Workshop on “Normal Conditions of Use”

Contribution by VDA Germany (OICA member)

EMC working group

May 2023, V1

Steady state: influence of the speed

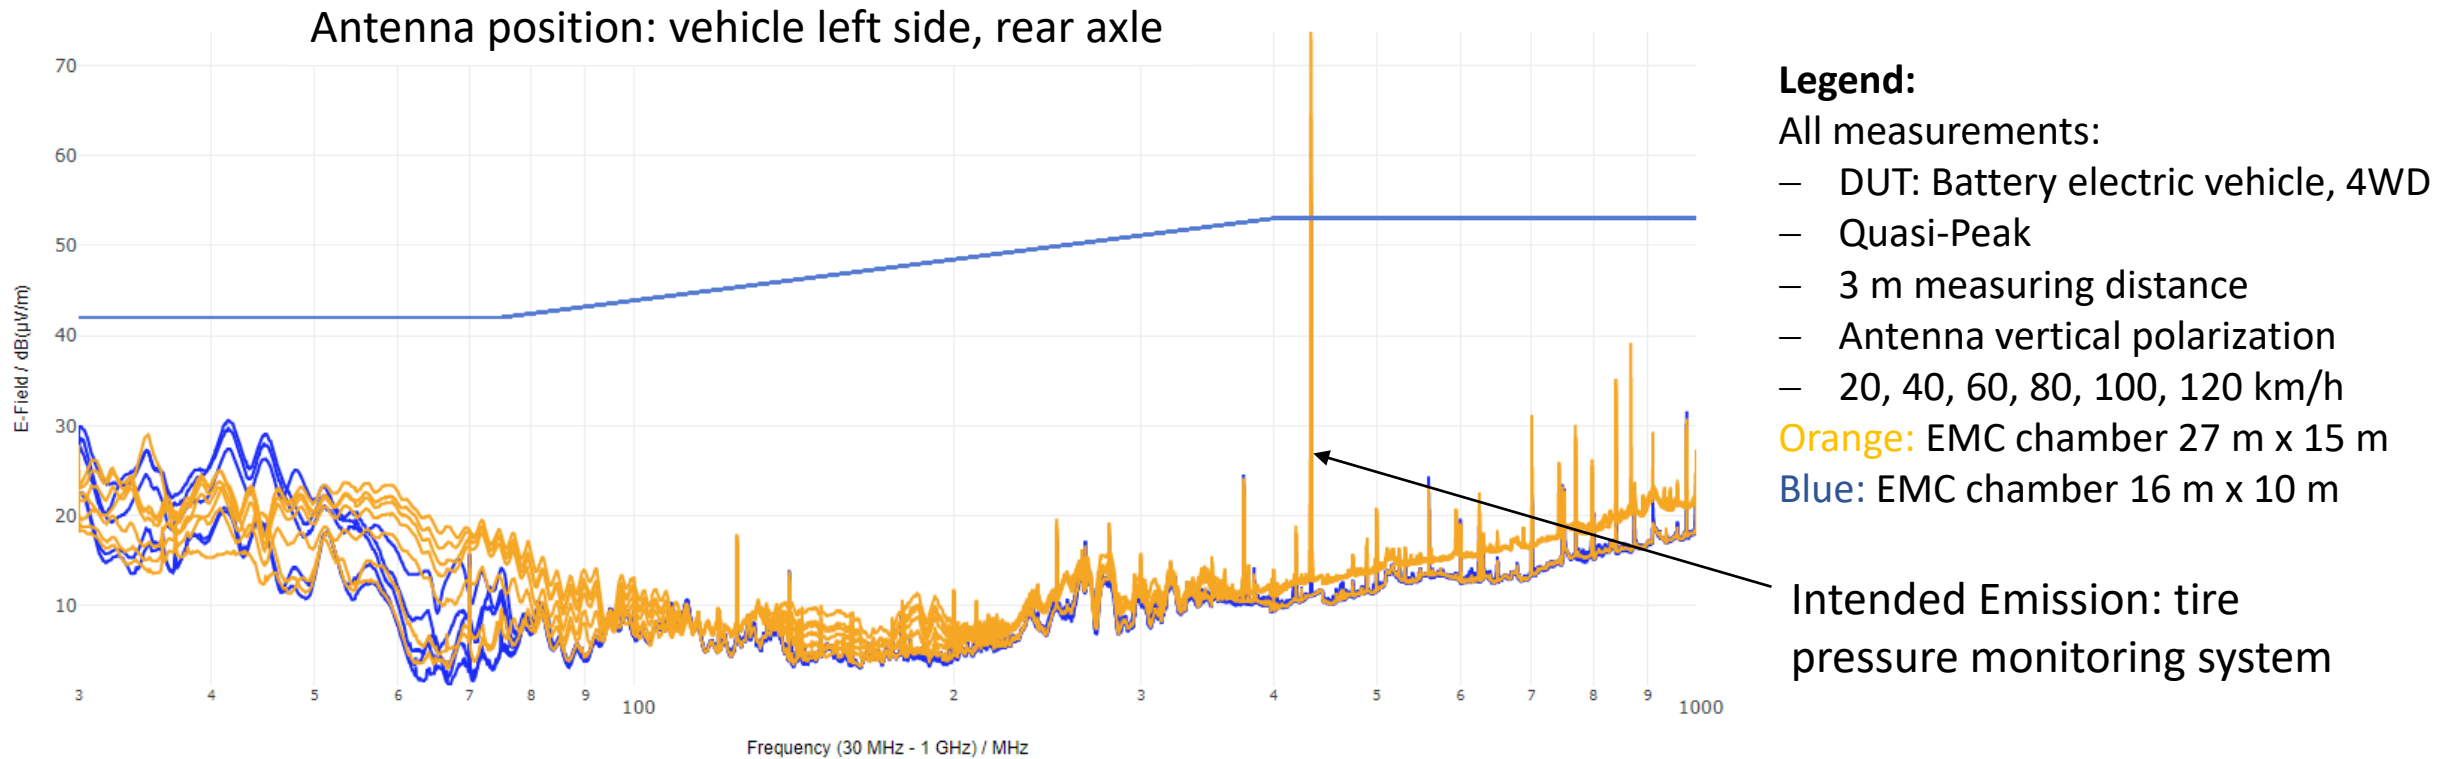
The table shows the difference in the measurement results of an electric vehicle with the speed.

- The margin to the limit decreases with the speed, until an ESD phenomena happened at 120 km/h.
- Nothing in the measurement result induces to believe there is a problem without a thorough investigation.
- This problem is an artefact produced by the chamber and is not representative of the vehicle behavior on the street.
- The chamber complies with UN ECE R10 requirements.

Steady state: comparison of two EMC chambers

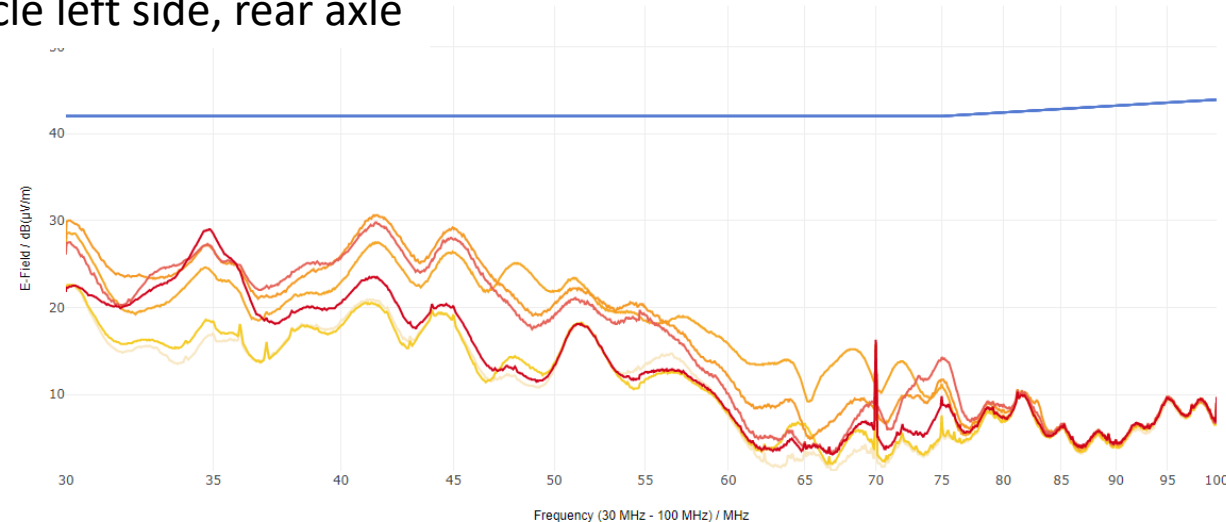
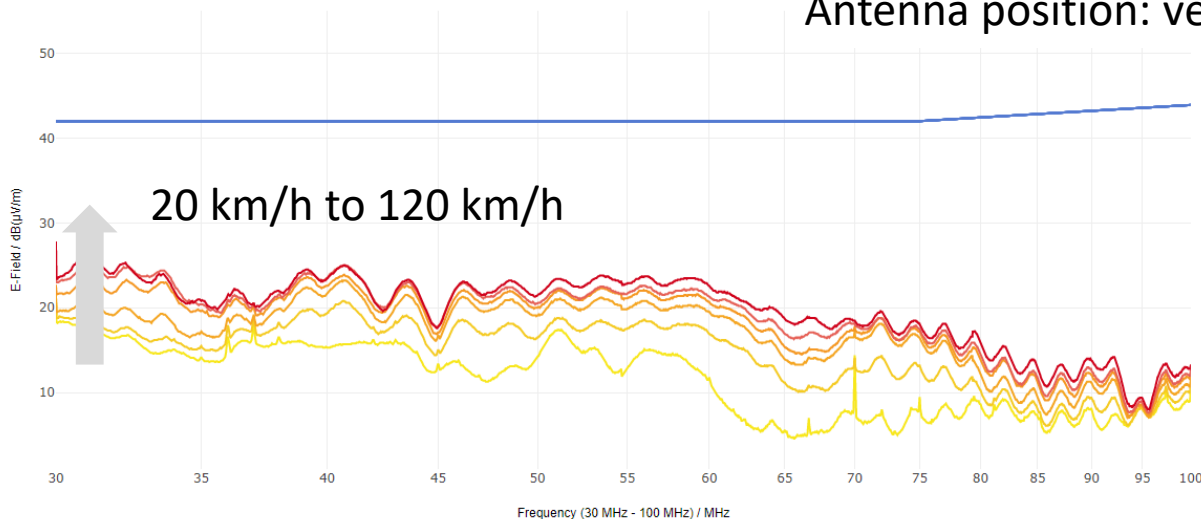
- High deviation between two EMC chambers / dynamometers in the frequency range 50 to 100 MHz.
- Both chambers fully comply with UN ECE R10 (CISPR 12) requirements.

Steady state: comparison of two EMC chambers

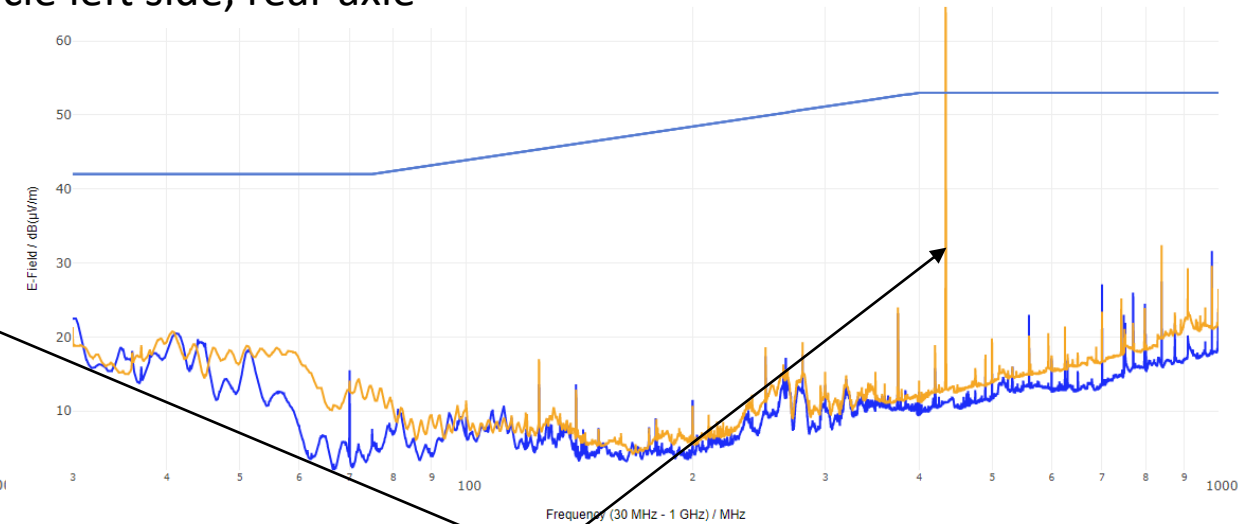
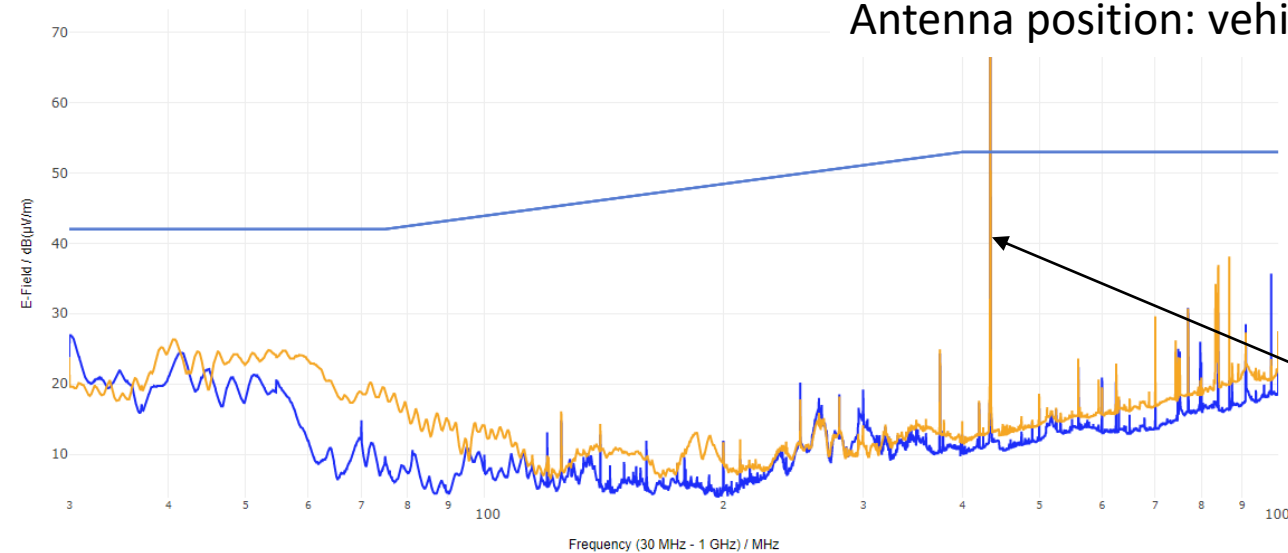
- In most cases increase of the speed will lead to higher emission.
- The dynamometer can be the root cause for higher emission.
- Higher emission limit is tolerable for higher speed, because interferer is present for a very short period of time.
- Measurements at higher speed do not provide added value.
